NCSX Milestone Report

Progress on PVR Recommendations

Attachment 1. NCSX SIZE AND HEATING REQUIREMENTS

Figure 1. Contours of constant $H_{ITER-97P}$, H_{ISS-95} and collisionality $\nu^*=0.25$ for (a) $P_{inj} = 6$ MW and (b) $P_{inj} = 3$ MW.

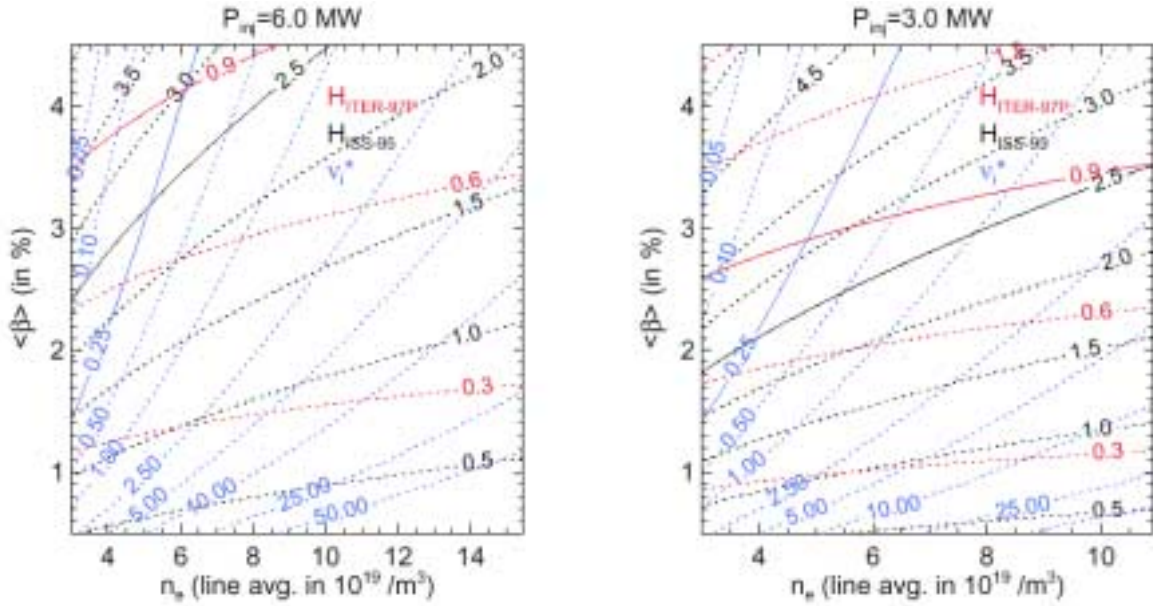
The choice of the NCSX machine size (major radius) is an important decision that balances project cost with experimental performance. The Physics Validation Review committee expressed a concern that the size is too small, citing examples of parameters considered to be marginal. They also had a concern that critical parameters were being fit to a predefined budget envelope. The committee recommended that the project give continued attention to this issue and carefully justify its choices.

Figure 1b shows that with 3 MW injected and with $H_{\text{ITER-97P}} = 1$ and $H_{\text{ISS-95}} \approx 2.9$, it is possible to reach $\langle\beta\rangle = 3.5\%$ at relatively high collisionality, $\nu_i^* = 1$, or a lower beta $\langle\beta\rangle = 2.7\%$ at low collisionality, $\nu_i^* = 0.25$ (the target value). Given the flexibility of the coils to move stability boundaries in beta (confirmed by post-PVR analysis with the latest coil design), the conditions accessible with 3 MW should be enough to complete some tests of beta-limit predictions. These same H factors produce the target $\langle\beta\rangle = 4.0\%$ at low collisionality, $\nu_i^* = 0.25$ if the NBI heating power is increased to 6 MW. The design accommodates this possibility as an upgrade. In fact, NBI access has improved as a result of coil design changes that eliminate coils from the $\nu = 0$ symmetry plane. High-power (up to 6 MW) mode conversion radiofrequency heating can also be accommodated now due to a design modification to allow installation of a high-field-side launcher. The need and optimum configuration for heating upgrades will be determined by initial results with the baseline 3 MW NBI system.

Figure 3. Two-dimensional plots of the log of the neutral atom density and the ion source rate obtained with recycling at an outboard limiter. To facilitate computation of the logarithm, factors of 10^9 and 10^{10} , respectively, were first added to the data

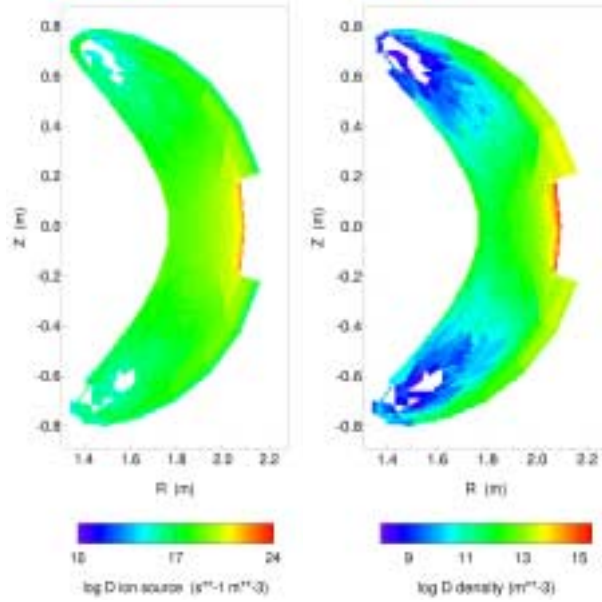
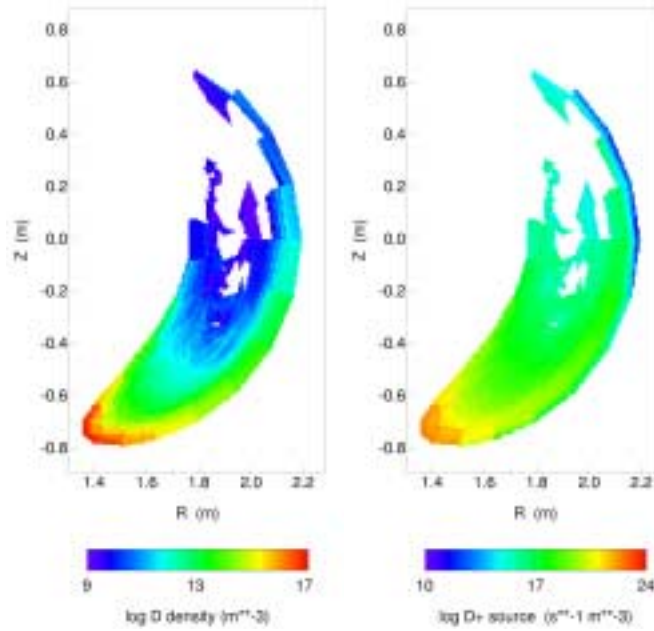
An important requirement for the NCSX design is that the neutrals generated at the plasma boundary do not penetrate too far into the plasma discharge for a reasonable range of operating parameters. Deep penetration of the neutrals could lead to an unacceptable energy loss channel. To address this issue the DEGAS 2 code was used to model the neutral penetration, first with recycling occurring at an outboard limiter and then, with the recycling occurring at a divertor baffle. This modeling effort was documented in Sect. 11.8 of the PVR document. Figures 3 and 4 summarize the results. Figure 3 models a neutral source at the outboard mid-plane and in Figure 4 the source is at the banana tips. If the plasma is limited at the midplane, the scale lengths for both the neutral density and the ion source rate in front of the mid-plane limiter are about 0.8 cm. The neutral density at the magnetic axis is roughly 10^{-3} of the peak value for the midplane limiter configuration. For case with the neutral source at the banana tip the neutral density and ionization source at the magnetic axis are effectively equal to zero. Thus, it is very important to ensure that recycling occurs at the banana tips and not the mid-plane. This is the project's design objective.

Neutrals control in NCSX looks promising when compared with the recent experimental results on W7-AS [P. Grigull, EPS 2001]. The W7-AS has only about ~18 cm diameter in the midplane of the bean-shape cross-section ($v_s \geq 24$ cm in NCSX) and has, nevertheless, achieved excellent plasma performance with the island divertor operation. In particular, density control and plasma collapse which used to be a problem in W7-AS before the installation of the divertor, has been solved due to a combination of recycling control and particle confinement. It appears that the divertor plates and baffles provide the needed neutrals control at the source so that the neutral penetration at the midplane should not be a machine size determinant but careful design of the PFC configuration and location are important for neutral control. We are taking this approach to developing the conceptual design. An initial assessment of the space available for implementing such a divertor on NCSX is encouraging.

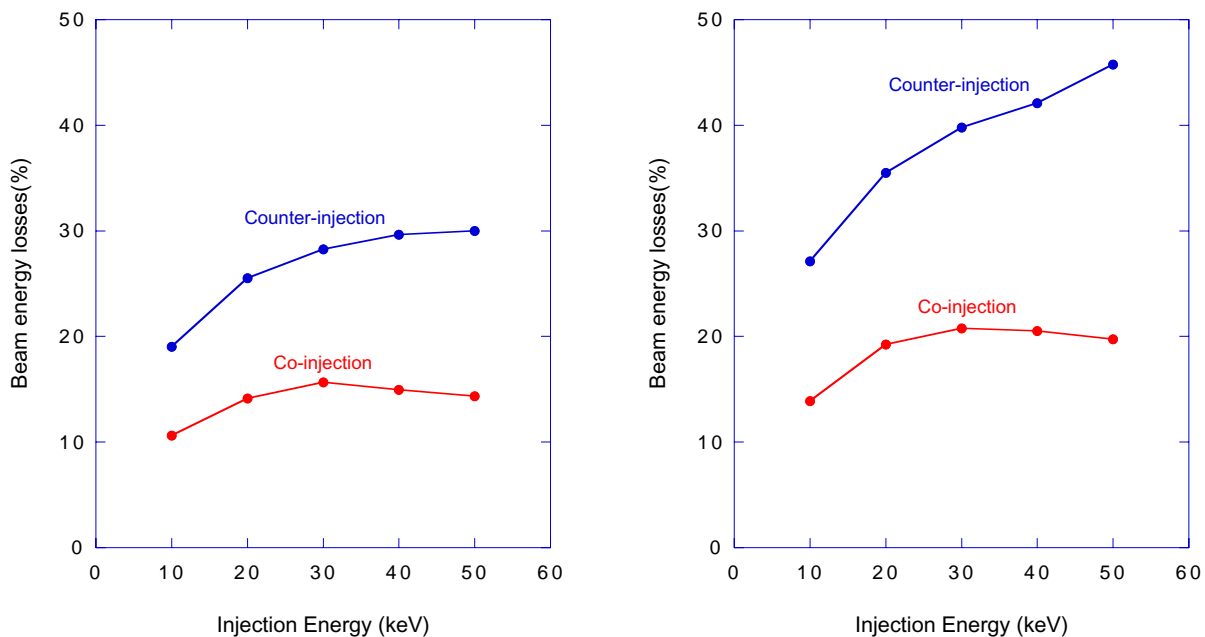
Beam injected ion orbit confinement is generally an issue for experiments the size of NCSX. In addition, the unique symmetry of NCSX may impact high energy ion orbit characteristics. For this reason orbit analysis has received special attention as part of the NCSX design process. This work is documented in Sect. 7.3 of the PVR documentation.

Figure 5 summarizes the beam ion loss studies. Beam deposition has been modeled using axisymmetric models with the plasma cross-section of the tangency cross-section in the actual geometry. Beam ion dynamics have been modeled using the actual 3D equilibrium. The loss of injected energy is significant but not prohibitive. The confinement studies have taken these losses into account in projecting operating points. Thus, while a larger machine would increase the operating range in magnetic field and in density (for limiting collisional orbit characteristics), the 1.4-m device is adequate.

Figure 6. NBI footprint (circles) for the most poorly focussed beam superimposed on the oblate plasma cross section. The larger circle encloses ~96% of the injected power, the smaller circle encloses 47%.

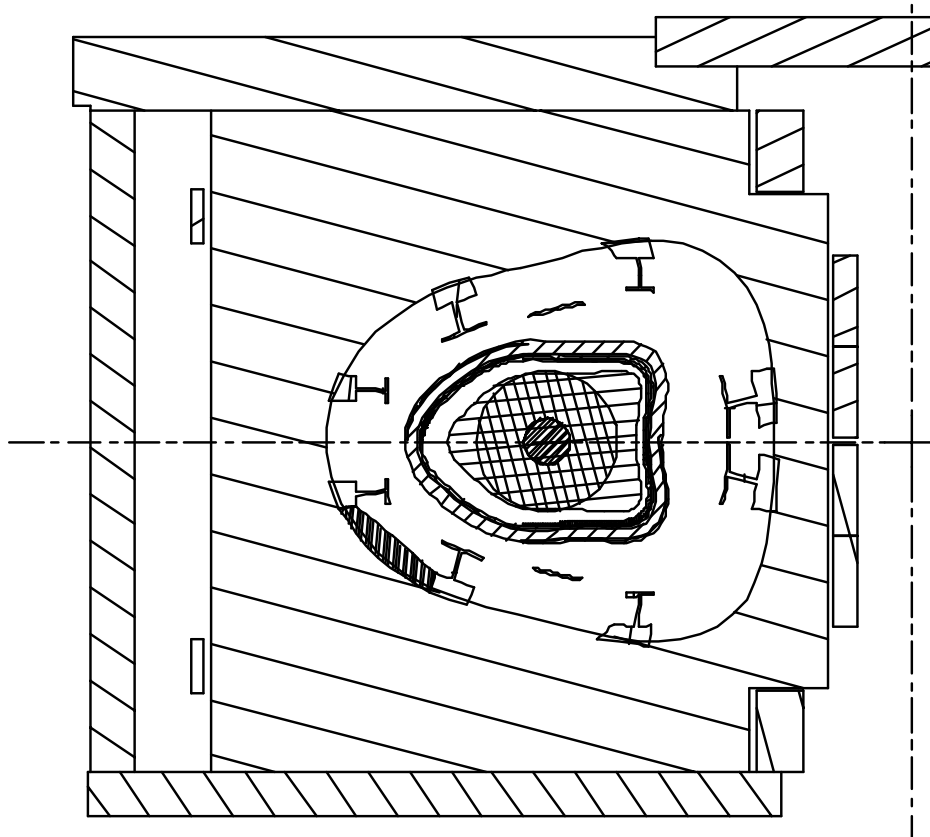
The overall machine size affects the access for personnel, heating (particularly beam heating) and diagnostics. The status of the access for the NCSX configuration and size are summarized below for each of these areas.

The neutral beam optics has been modeled for the PBX neutral beams in the NCSX geometry. The modeling uses the measured PBX beam characteristics as input. Front-end cryopumping is provided to eliminate reionization losses in the duct. As a result, it is projected that the full 1.5 MW per beamline will be injected into the torus. The beam “footprint” size is not small compared to the plasma cross section, as shown in Figure 6, but does enclose more than 90% of the injected power from the most poorly focussed beam. These beam transmission levels are adequate and therefore should not be a size or configuration driver.
